## Technical Service Bulletin

New installations of 2100 Series room heaters manufactured with manual reset limit switches which are being installed in high altitude applications (above 6,000 feet).

FIGURE 1

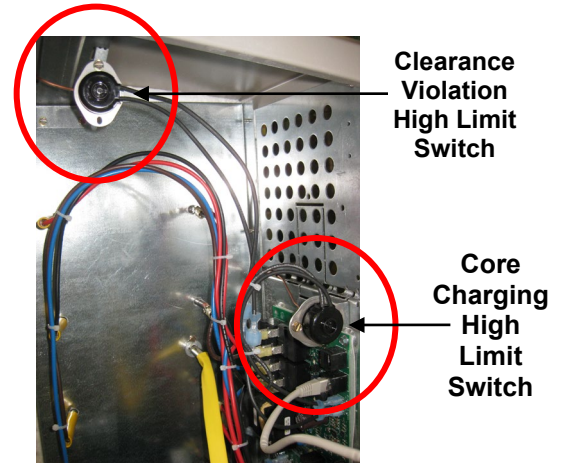
When installing 2100 series room heaters in high altitude applications (above 6,000 feet), the core charging limit switch may open prematurely. This requires a service call to reset the manual reset limit switch. Depending on altitude, the limit switch could trip multiple times.

When installing a new 2100 Series heater in a high-altitude application, change the maximum core temperature set in Location 40 (L040) to the appropriate value according to the table below (Figure 2):

Altitude at Installation Site	Maximum Core Temperature (Location 40)
6000	1050
7000	1000
8000	950
9000	900

**NOTE:** *The storage capacity of the 2100 Series heaters will be reduced by approximately 5% for every fifty degrees. For example, at 7000 feet, the maximum core temperature would be reduced by 100 degrees, so the storage capacity would be reduced by approximately 10%.*
